CURTISS P-40
BULLETINS

TECHNICAL ORDER
No. 01-25C-7

CURTISS—OPERATION, MAINTENANCE, AND INSTALLATION INSTRUCTIONS FOR CARBURETOR AIR FILTERS—P-40E, P-40E-1, P-40K SERIES AND P-40M

Figure 2 - Receiver Mounting Relocation -
Aft Section of Baggage Compartment

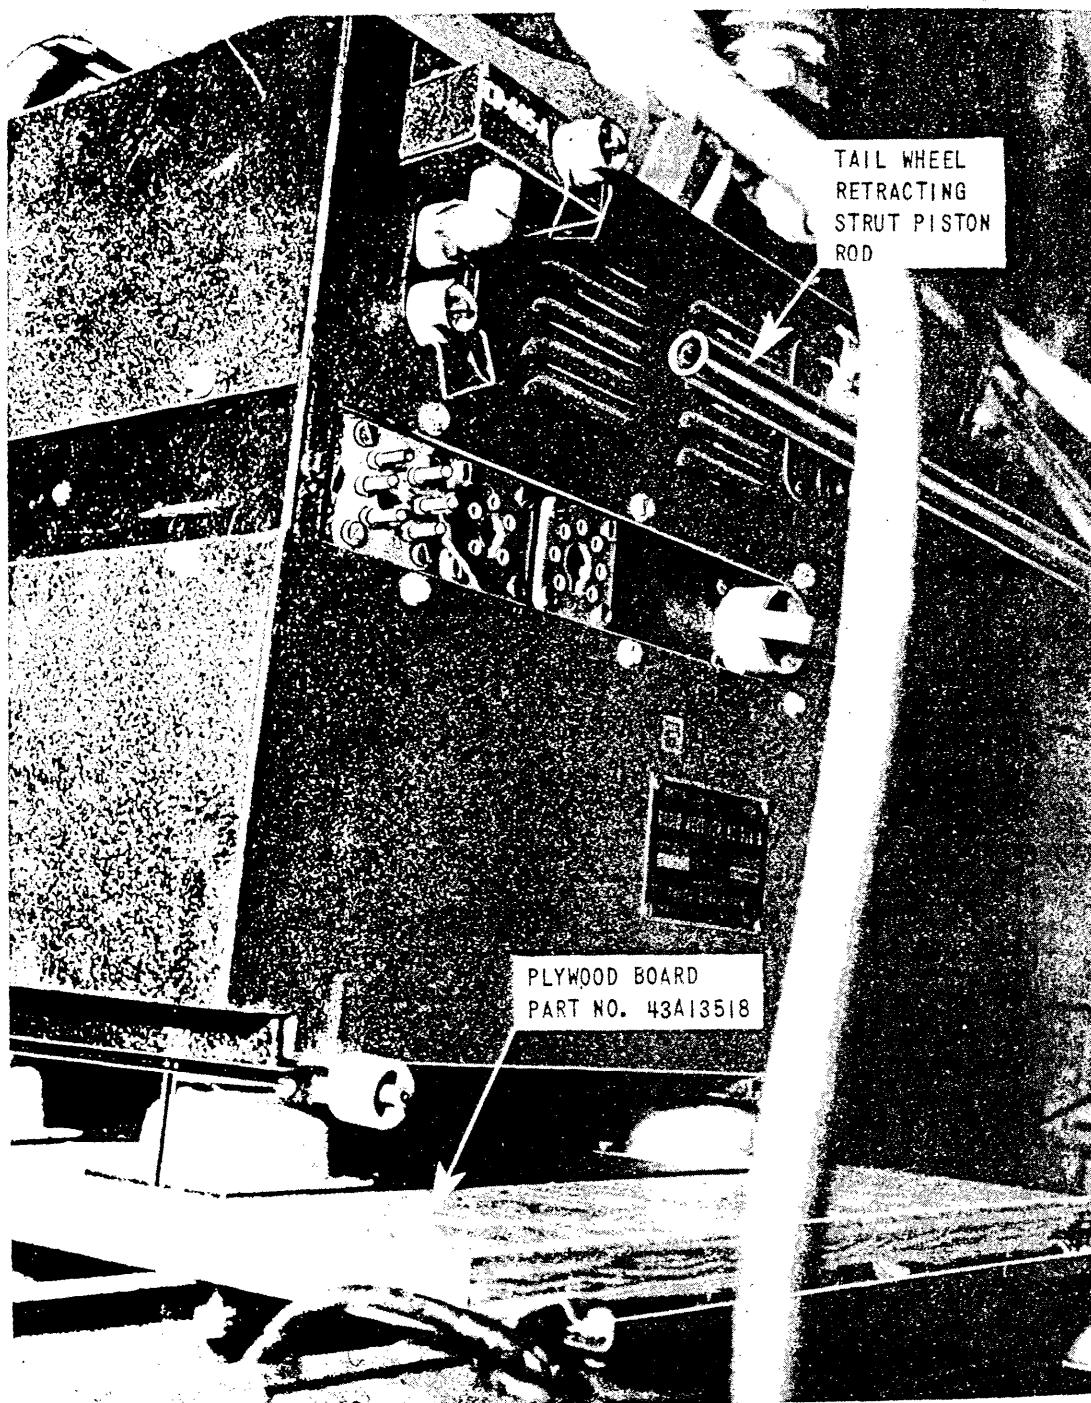
b. RELOCATION OF RECEIVER MOUNTING
FT-247-A. (See figure 2.)

Figure 1

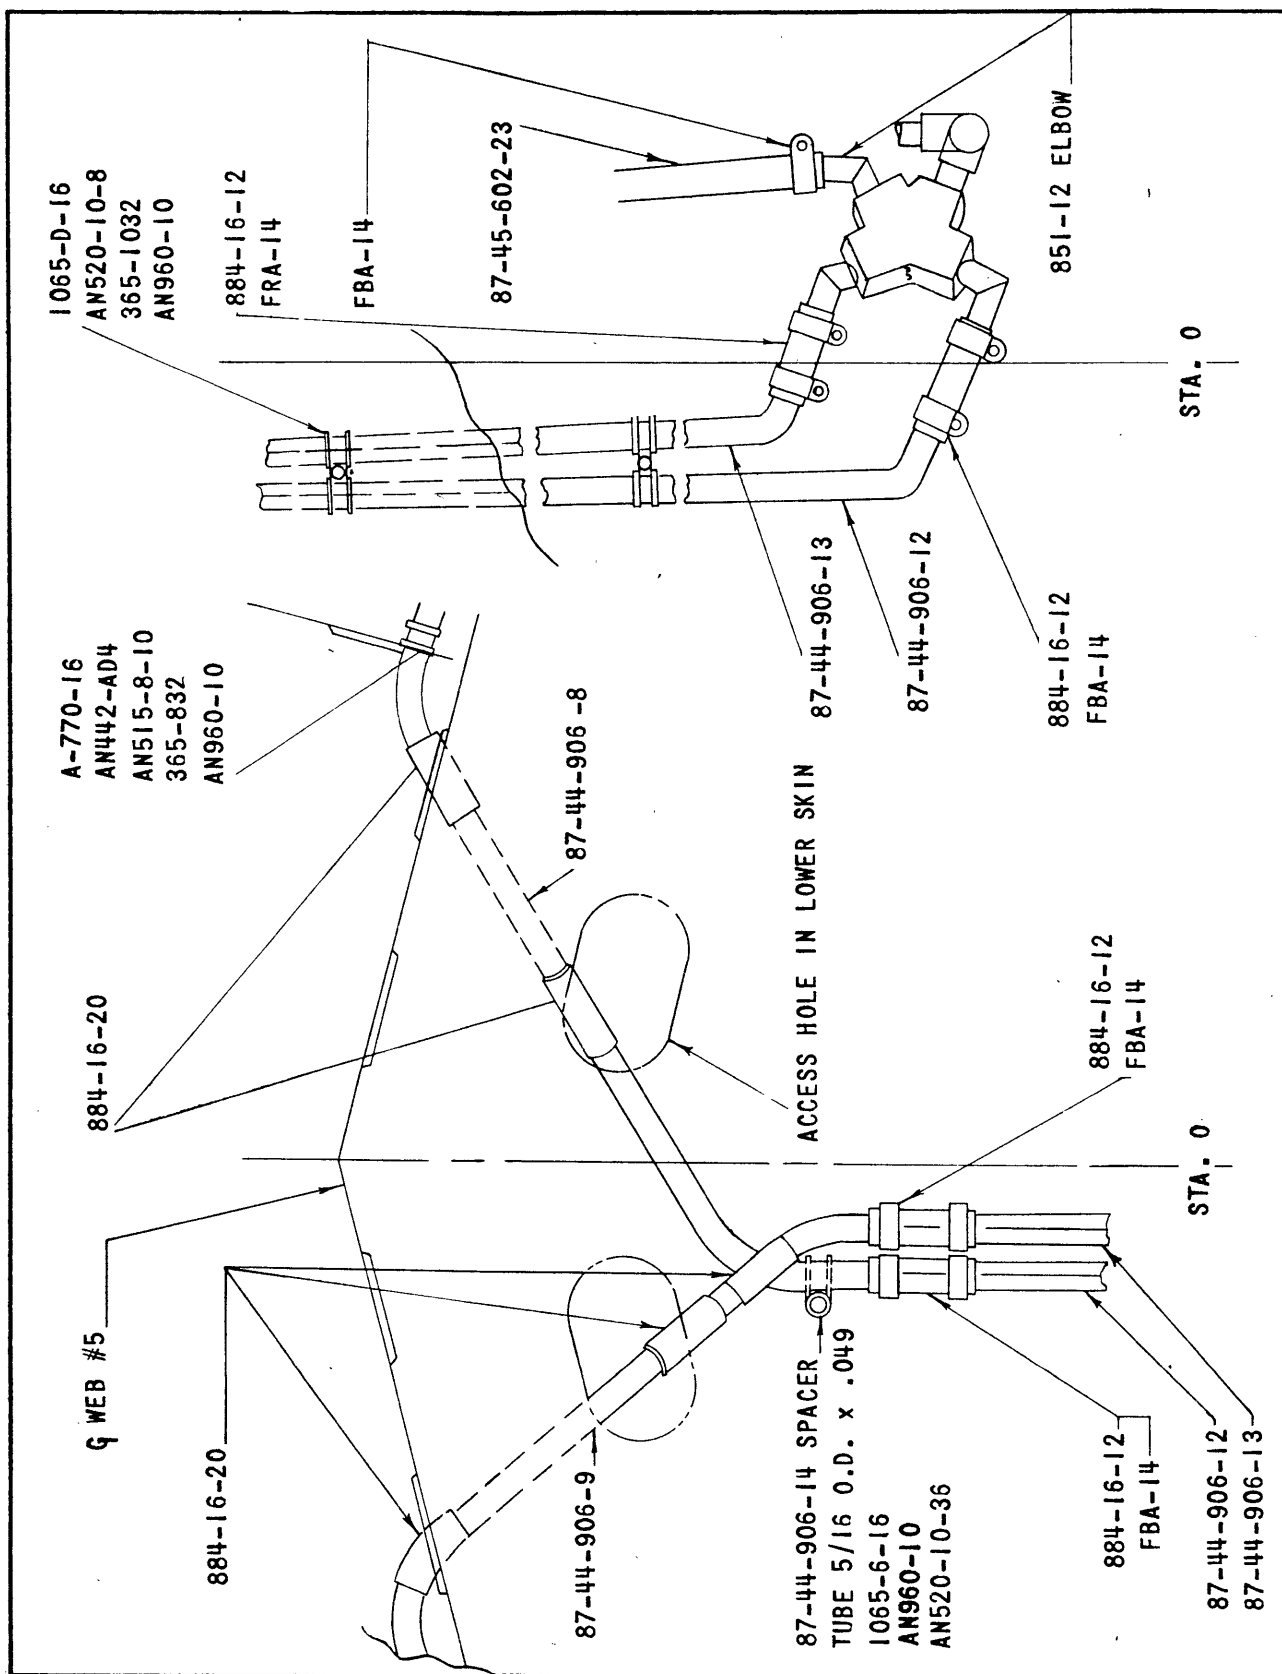
ai. Insert tube, part No. 87-44-906-8, on left panel through web No. 5 (figure 1) and connect to tube, part No. 87-44-906-2, using one hose, part No. 884-16-12, and two clamps, part No. FBA-14.

ak. Install two hose, part No. 884-16-20, on tube (figure 1) to prevent chafing.

al. Insert tube, part No. 87-44-906-9, on right panel through web No. 5 (figure 1) and connect to tube, part No. 87-44-906-2, using one hose, part No. 884-16-12, and two clamps, part No. FBA-14.

an. Install three hose, part No. 884-16-20, on tube (figure 1) to prevent chafing.

ap. Connect tube, part No. 87-44-906-12, to belly tank port of selector valve (figure 1), using one hose, part No. 884-16-12, and two clamps, part No. FBA-14.

ar. Connect tube, part No. 87-44-906-13, to former front wing tank port of selector valve (figure 1), using one hose, part No. 884-16-12, and two clamps, part No. FBA-14.

as. Connect tube, part No. 87-44-906-13, to tube, part No. 87-44-906-12, in two places (figure 1), using four clamps, part No. 1065-D-16, two each, screw, part No. AN520-10-8, washer, part No. AN960-10, and nut, part No. 365-1032.

at. Remove screw from tank door and fasten tube, part No. 87-44-906-8, to panel, using spacer, part No. 87-44-906-14, and one clamp, part No. 1065-D-16, one washer, part No. AN960-10, and screw, part No. AN520-10-36. (See figure 1.)

Figure 2

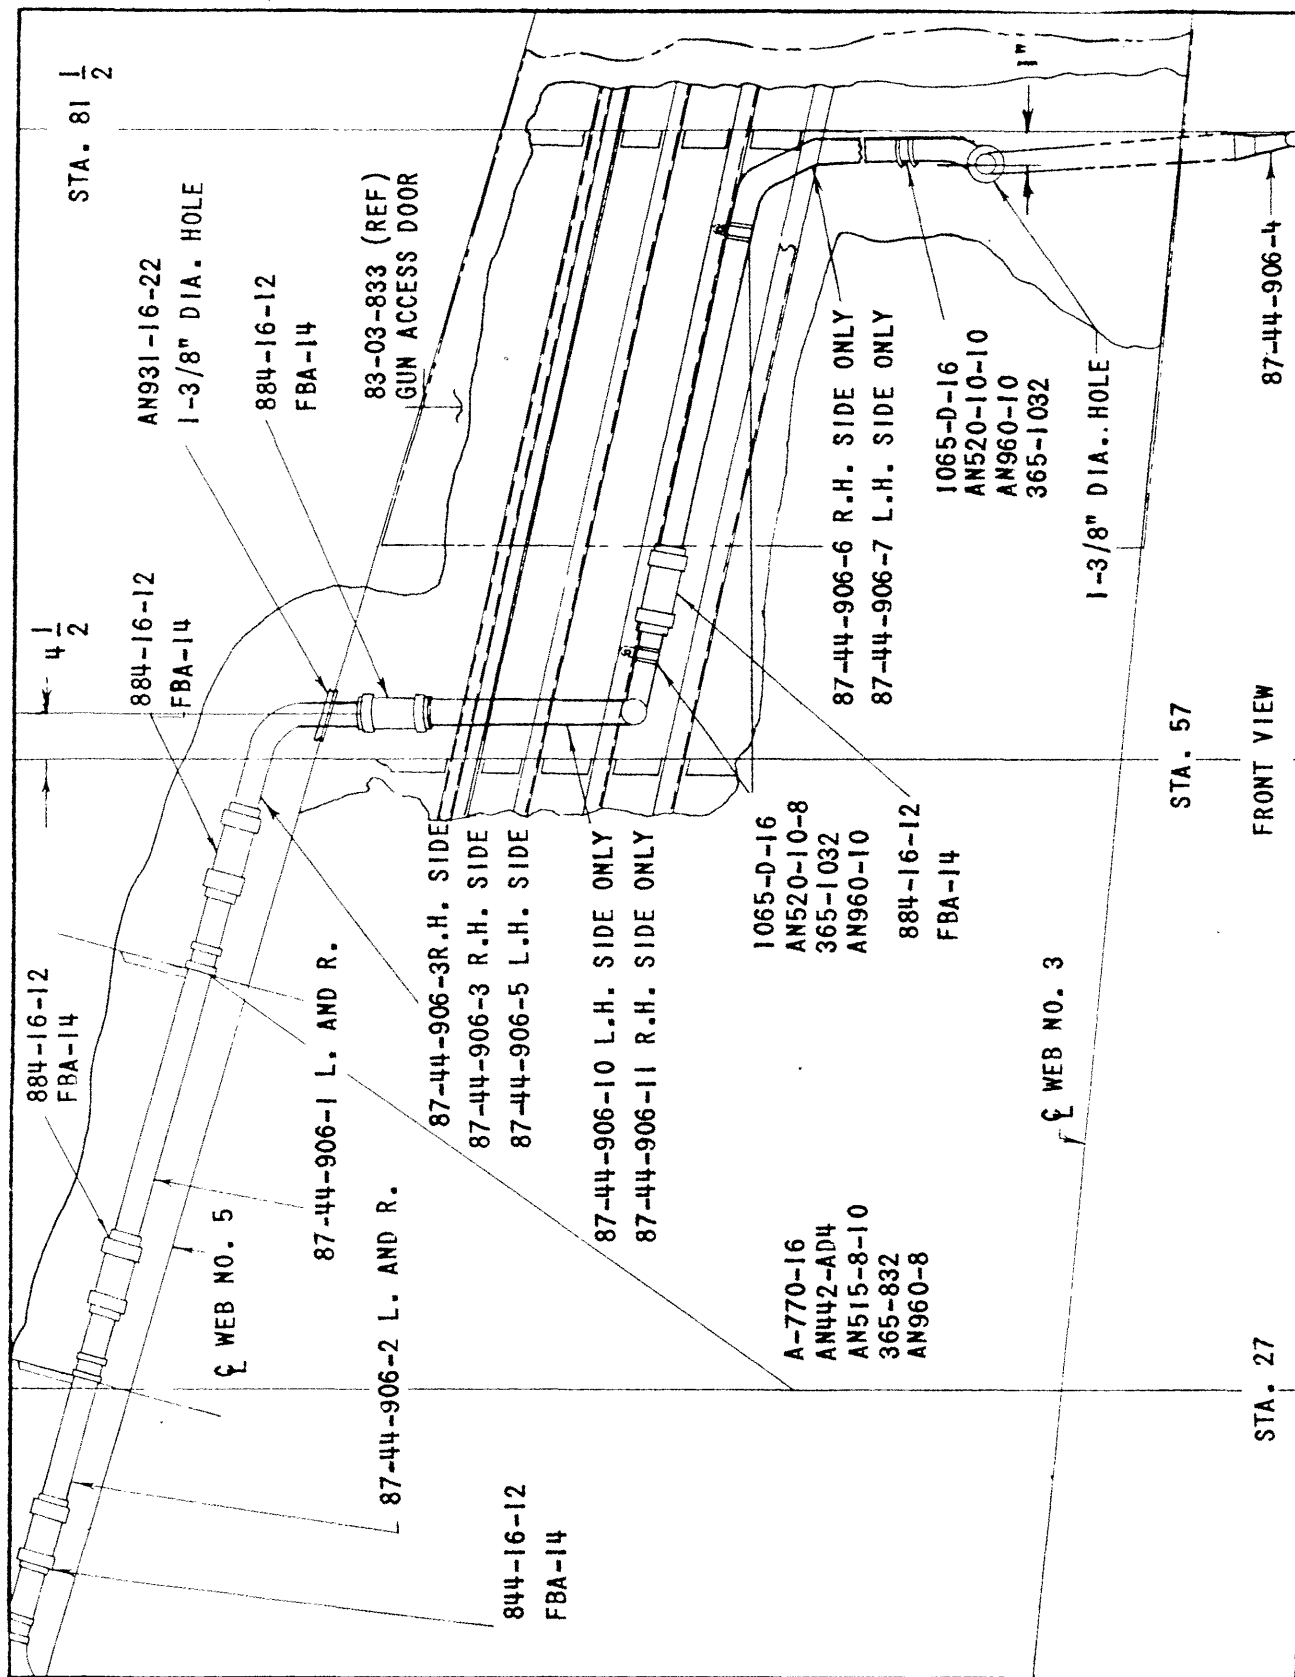
- a. Remove keel cowl and center section of left and right wing fillets.
- b. Remove wing guns.
- c. Locate and cut one 1-3/8 inch diameter hole in No. 5 web on left and right wing. (See figure 2.)

- d. Install a grommet, part No. AN931-16-22, in each hole.
- e. Locate and cut one 1-3/8 inch diameter hole in each gun access door. (See figure 2.)
- f. Locate and cut one 7/16-inch diameter hole in lower left and right panel skin. (See figure 4.)

y. Install tube, part No. 87-44-906-10, on the left panel, and tube, part No. 87-44-906-11, on the right panel, in gun compartment. (See figure 2.)

z. Secure tube, part No. 87-44-906-10, to bulkhead, station 81-1/2, using one each clamp, part No. 1065-D-16, screw, part No. AN520-10-10, washer, part No. AN960-10, and nut, part No. 365-1032. (See figure 2.)

aa. Secure tube, part No. 87-44-906-10, to stringer (figure 2), using one each, clamp, part No. 1065-D-16, screw, part No. AN520-10-8, washer, part No. AN960-10, and nut, part No. 365-1032.

ab. Connect tube, part No. 87-44-906-7, on left panel, and tube, part No. 87-44-906-6, on right panel to tube, part No. 87-44-906-10 (figure 2), using one hose, part No. 884-16-12, and two clamps, part No. FBA-14.

ac. Secure tube to stringer (figure 2), using one each, clamp, part No. 1065-D-16, screw, part No. AN520-10-8, washer, part No. AN960-10, and nut, part No. 365-1032.

ad. Insert tube, part No. 87-44-906-5, on left panel and tube, part No. 87-44-906-3, in right panel through hose in web No. 5 and connect to tube, part No. 87-44-906-7, using one hose, part No. 884-16-12, and two clamps, part No. FBA-14. (See figure 2.)

af. Secure tube to bulkhead (figure 2), using one each, angle, part No. A-770-16, screw, part No. AN515-8-10, washer, part No. AN960-8, nut, part No. 365-832, and two rivets, part No. AN442-AD4-4.

Figure 3

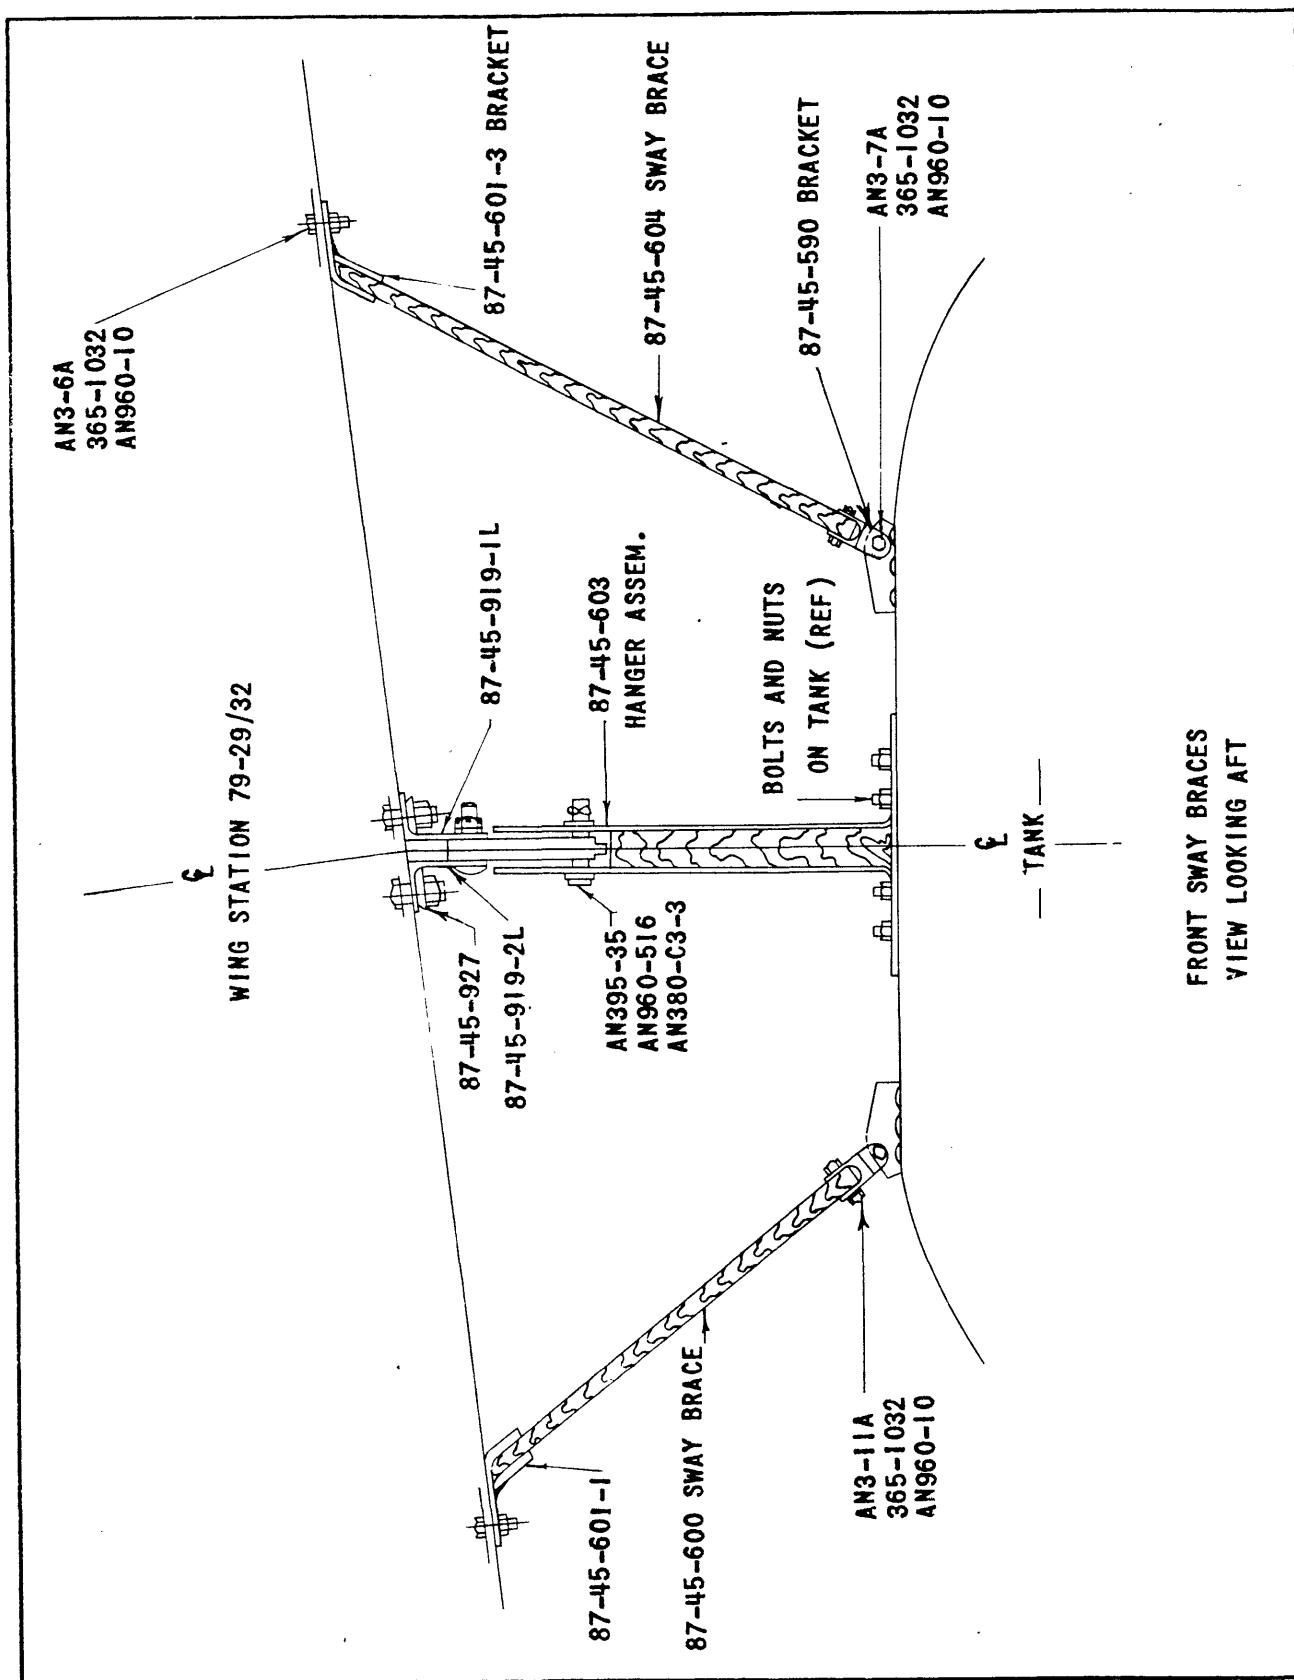
bq. Install hanger assembly, part No. 87-45-603 (figure 3), using present nuts and washers.

bs. Locate and bolt front weld assembly, part No. 87-45-590, to sway brace, part No. 87-45-604, using two each, bolt, part No. AN3-11A, washer, part No. AN960-10, and nut, part No. 365-1032, and bolt to clip on the tank by using one each bolt, part No. AN3-7A, washer, part No. AN960-10, and nut, part No. 365-1032. (See figure 3.)

bx. Locate position of sway brace brackets on lower wing skin and drill two No. 10 (.194-inch) holes, pin bracket and install brackets, using four each, bolts, part No. AN3-6A, washer, part No. AN960-10, and nut, part No. 365-1032. (See figure 3.)
